Curved Hoisting Monorails

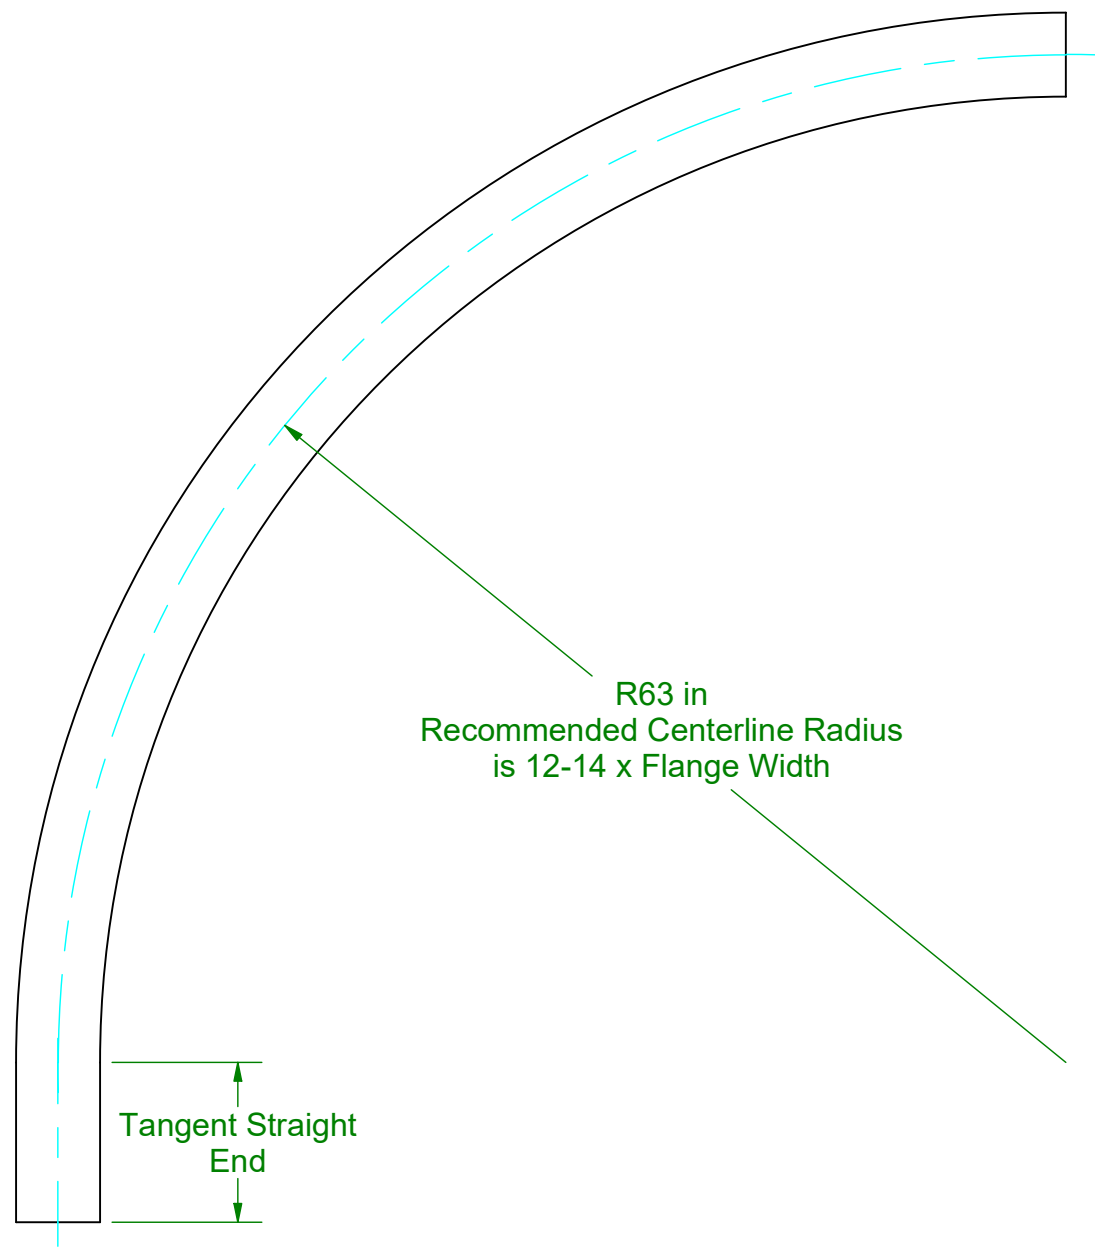
- Flange width variance of more than 1/2" over 30'

- Flanges that are not parallel to each other

- Web that is not centered on the flanges

- Differences in flange width of top as compared to bottom

We have had to reject beams as un-formable due to these issues. Please ensure that beams selected for monorails adhere to a high standard of tolerances regarding these areas.

R63 in
Recommended Centerline Radius
is 12-14 x Flange Width

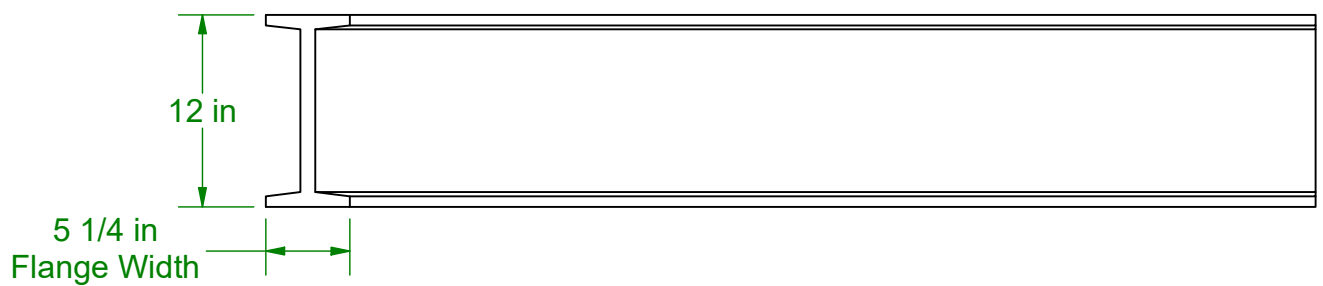
This is an example of S12X40.8 Monorail.
The flange width of this monorail is 5.25".
Therefore, the recommended centerline radius will be at least
12 X 5.25" which is 63".
